RE: Consent Decree (Case: No. 1:12-cv-24400-FAM)
Reference DOJ Case No. 90-5-1-1-4022/1
Section VIII –Supplemental Environmental Project, Paragraph 23
Section XX – Modification
Appendix E – Supplemental Environmental Project Plan
Request for Non-Material Change – Supplemental Environmental Project Plan

Request for Non-Material Change

Section VIII & Appendix E Supplemental Environmental Project Plan

Technical Memorandum

Figure 1: Miami-Dade County, Consent Decree, Appendix E, SEP Graphic

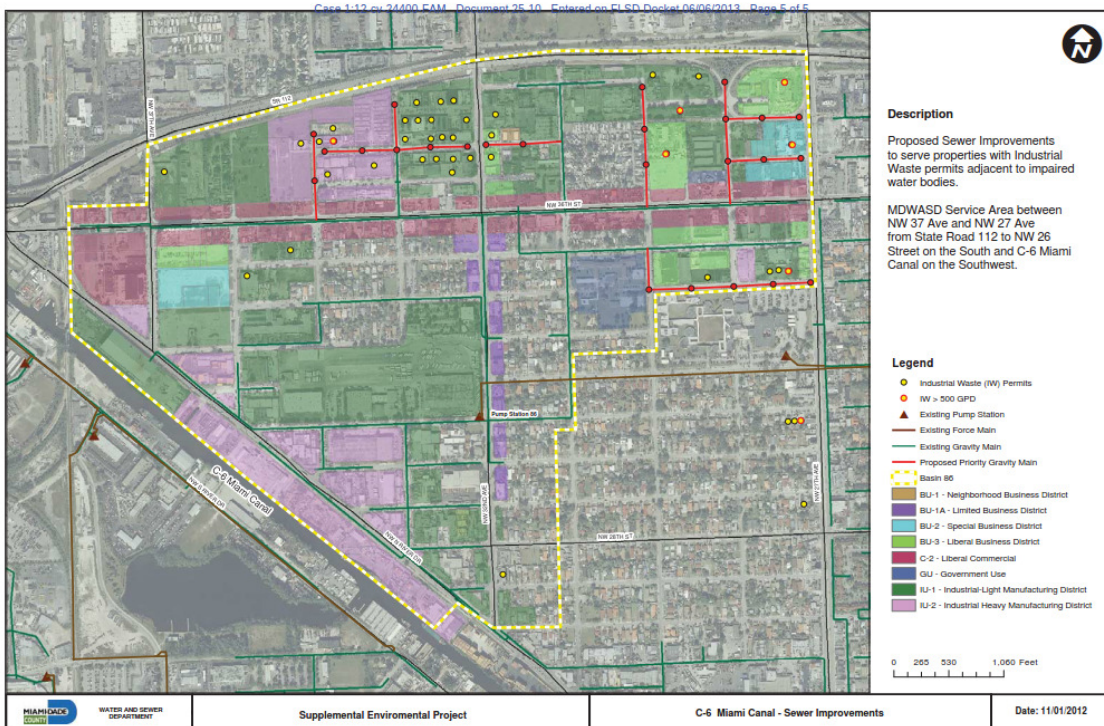
Appendix E provided a written description of the Consent Decree requirements for the SEP. The locations of “proposed gravity mains” shown on the Appendix E graphic were drawn by the County based on planning-level analysis, and were therefore subject to refinement based upon further engineering study and design. Due to low existing ground elevations within a portion of the area identified in Appendix E, which result in insufficient soil cover over new pipes in certain areas, the County concluded a new gravity sewer main system was not technically feasible within a portion of the area identified in Appendix E without the usage of low pressure systems or a new sub-basin lift station. In light of the technical problems the County is proposing a solution that would not only meet, but exceed, the SEP Consent Decree requirements in the following manner:

The CD 6.00 SEP area is located within Miami-Dade County Water and Sewer Department (WASD) Basin 0086. In particular, the SEP area is focused within the north-central and north-east portions of Basin 0086. Within this area, Appendix E provided a written description of the Consent Decree requirements for the SEP, which are summarized above. The locations of “proposed gravity mains” shown on the Appendix E graphic (i.e., see Figure 1 above), were drawn by WASD based on planning-level analysis, and were therefore subject to refinement based upon further engineering study and design.

Figure 5: Build-Out of Sectors II and V
 [Source: HDR 9/13/2015 dBODR]

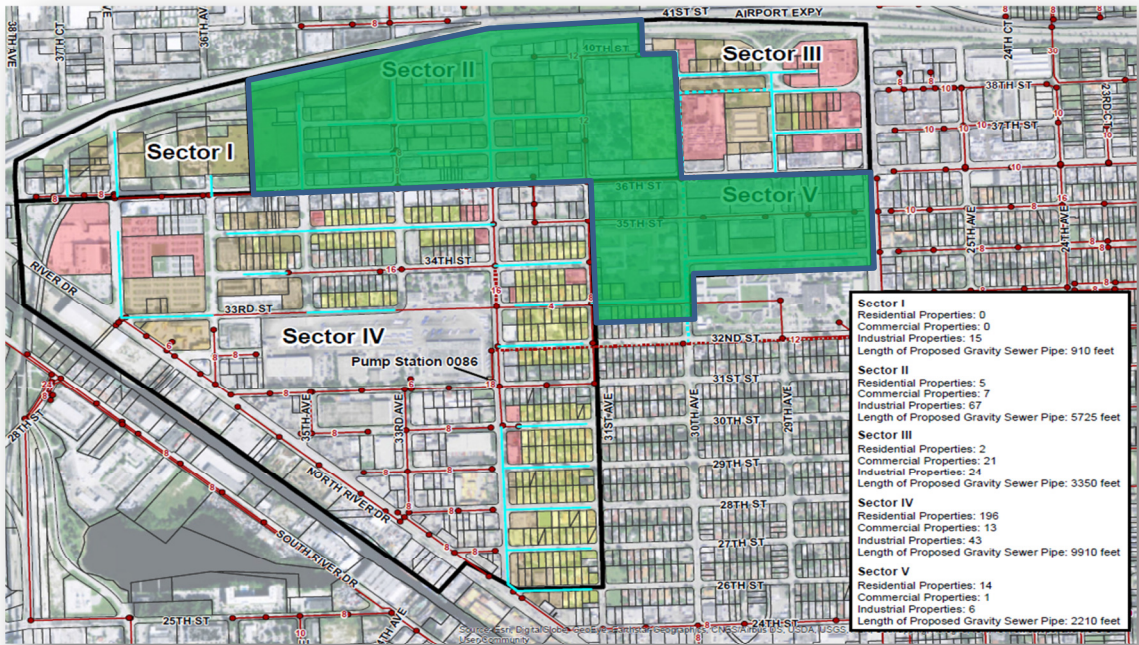
In light of the technical problems within Sector III, HDR investigated a build-out of only Sectors II and V (see Figure 5) and found that these two (2) sectors would not only meet, but exceed, the SEP Consent Decree requirements in the following manner:

- Provide a total of approximately 7,789 linear feet of new gravity sanitary sewer main, whereas the Consent Decree requires a minimum of 7,660 linear feet, thereby exceeding the requirement by approximately 129 linear feet
- Service approximately 100 properties currently reliant upon septic systems, including 81 “Business” properties, whereas the Consent Decree requires connecting to a minimum of 74 “Businesses”, thereby exceeding the requirement by 7 businesses
- Cost an estimated \$2,200,000 for construction only, whereas the Consent Decree requires at least \$2,047,200 be spent by Miami-Dade County on construction costs plus other WASD project-related expenses (i.e., planning, design, permitting, procurement and construction management), thereby exceeding the costs by at least \$152,000

HDR’s new wastewater flow projections are approximately 32,623 gallons per day for Sector II, and 5,296 gallons per day for Sector V. For Sectors II and V combined, this results in approximately 37,900 gallons per day of wastewater being removed from a septic system treatment, and being treated at a Miami-Dade wastewater treatment plant.

Figure 6: Approximate Locations of New Gravity Sanitary Sewer Mains Proposed Within Sectors II and V
 [Source: HDR 9/13/2015 dBODR]

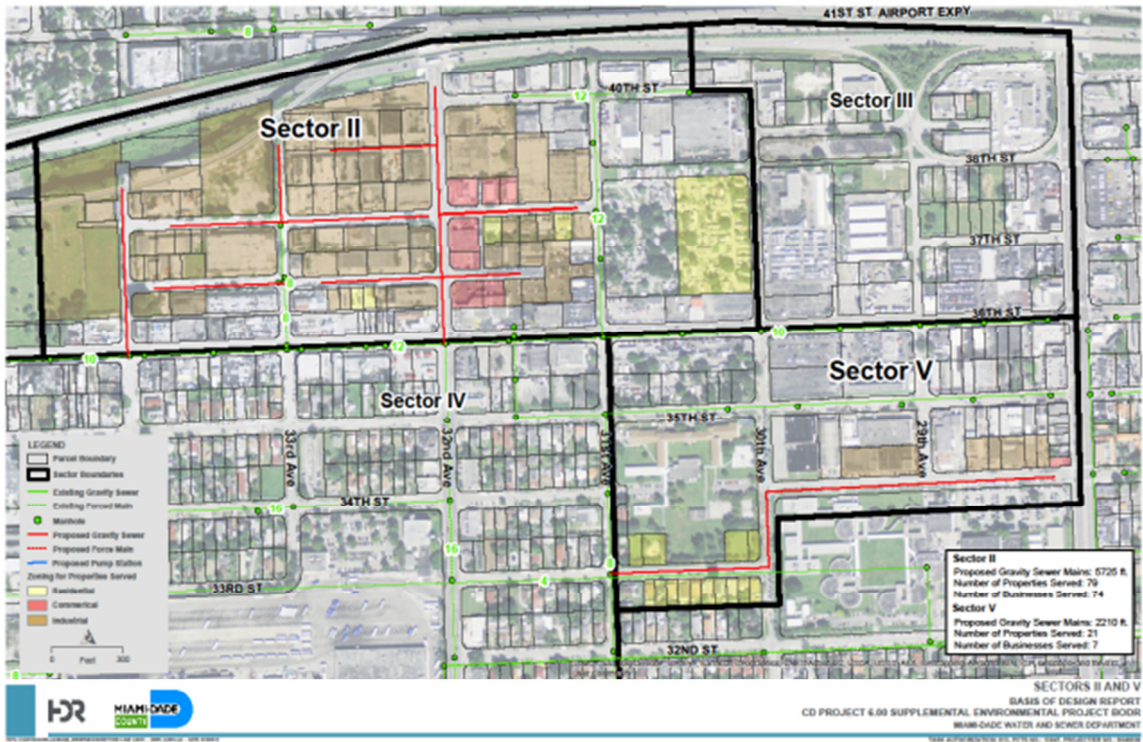
Figure 6 shows the approximate locations of the new gravity sanitary sewer mains proposed within Sectors II and V.

Based upon these findings, HDR's proposed gravity sanitary sewer mains for Sectors II and V not only meet, but exceed the Consent Decree requirements for the SEP. Furthermore, HDR calculated approximately 37,900 gallons per day of wastewater being removed from septic system treatment within Sectors II and V, and being treated at a Miami-Dade wastewater treatment plant. By providing these new WASD sanitary sewer connections to these properties currently relying upon septic systems, some of which pre-date existing septic system regulations, the SEP Plan's goal of improving water quality in the aquifer and nearby surface waters and preventing future contamination will be achieved.

The CD PMCM Team recommends development of Sectors II and V with new gravity sanitary sewer mains to comply with the Consent Decree SEP requirements.

PHASE I (SEP) CONCLUSION # 1

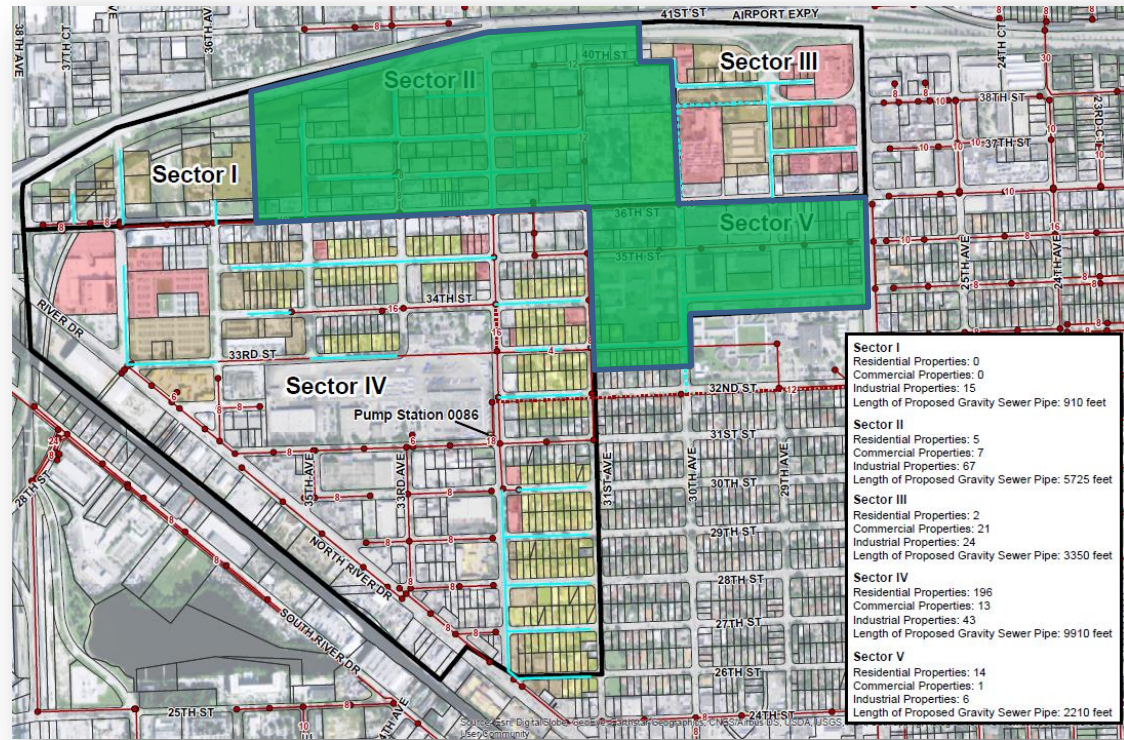
- Build-Out of Sectors II & V fulfill SEP compliance
- Approximately 100 properties were identified in Sectors II & V, including 81 Business Properties [74 Reqd]
- Total \cong 7,935 LF of new Gravity Sewer Main [7,660 Reqd]
- Total Cost \cong \$ 2,200,000 construction only [\$2,047,200 Total Cost Reqd]

PHASE I (SEP) CONCLUSION # 2

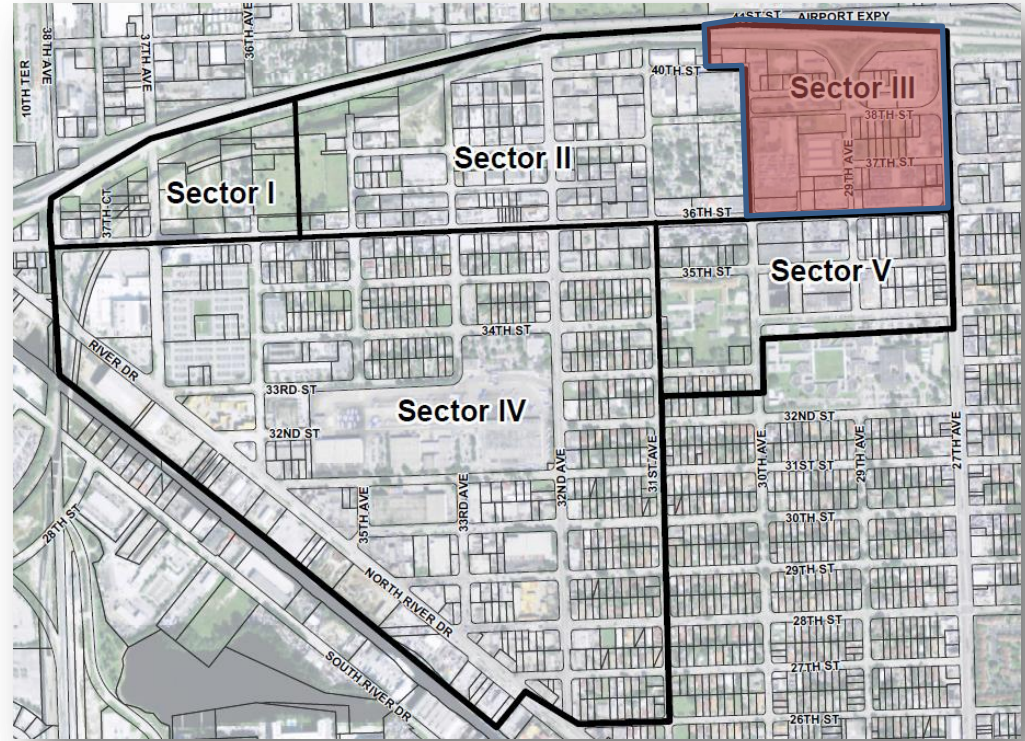
- Sector III, cannot be entirely served by gravity sewer while maintaining a constructible depth of cover
- Sector III can be served with gravity collection system with a localized pump station that would discharge to the receiving forcemain from PS086

RECOMMENDED SEP DESIGN

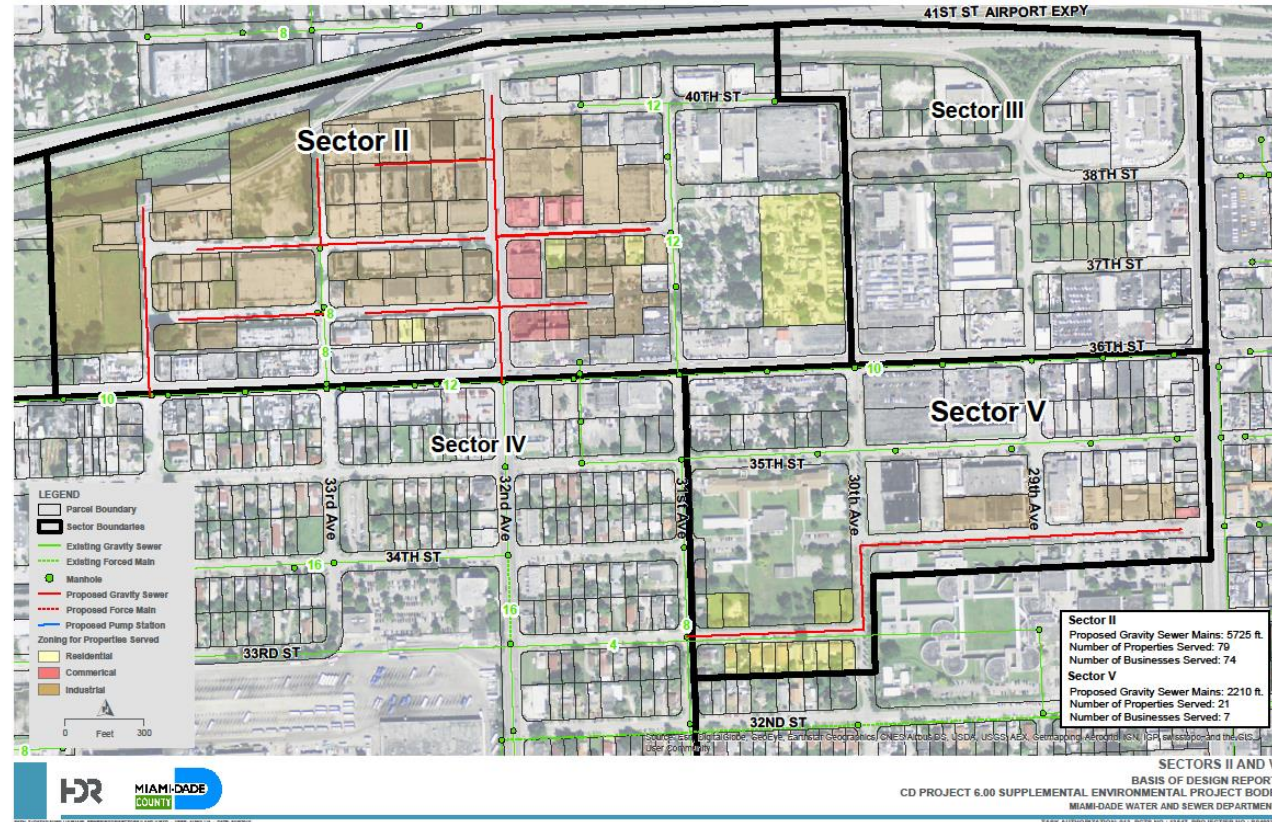
Design Gravity Sewer
Mains Build-Out for:

- Sector II
- Sector V
